London Borough of Camden Proof of Evidence Rear of 115-119 Finchley Road

Delegated Report and Decision for 2017/4737/P

**Unit to the rear of 115-119 Finchley Road
LONDON
NW3 6HY**

Proposal: Installation of external plant, including 3 no. extract ducts, 4 no. flues, 3 no. air intake louvres, 1 rooftop extract and 3 no. air condenser units (Retrospective).

June 2015 – Source Google Earth:

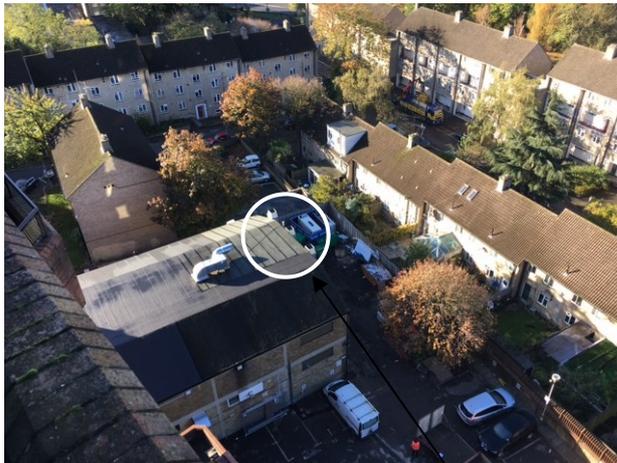
1.3. It is also note that submitted statements and reporting does not make specific mention of the pre-existing rooftop plant on site. As this equipment appears to have been installed without express planning permission within the last year (see appendix one), is within the 'red line' boundary of the site and is shown on submitted plans, the application also seeks to retrospectively apply for this equipment and the description has been amended accordingly.

permission and evidence points towards it being installed within the last 3 years (see appendix one of this report), it would be expected that the cumulative impact of all plant equipment be assessed together. Within the NIA, the cumulative impact assessment has not included the existing rooftop plant and only the 'Fläkt Woods' kitchen extract and AHU values are given in Appendix D/used within calculations. Without full details in relation to the overall predicted noise levels emitted from all plant within the site operating together, officers cannot be confident that levels at noise sensitive receptors would remain within acceptable limits. In fact, given that the predicted cumulative noise levels omitting the pre-existing rooftop plant are the same as the maximum design criterion for the daytime (44dB), a view is taken that the plant is unlikely to comply given the information presented at this stage. This view has been evidenced by the recent submission of numerous complaints received by the Council's Environmental Health team from local residents with regard to disturbances from noise associated with plant equipment.
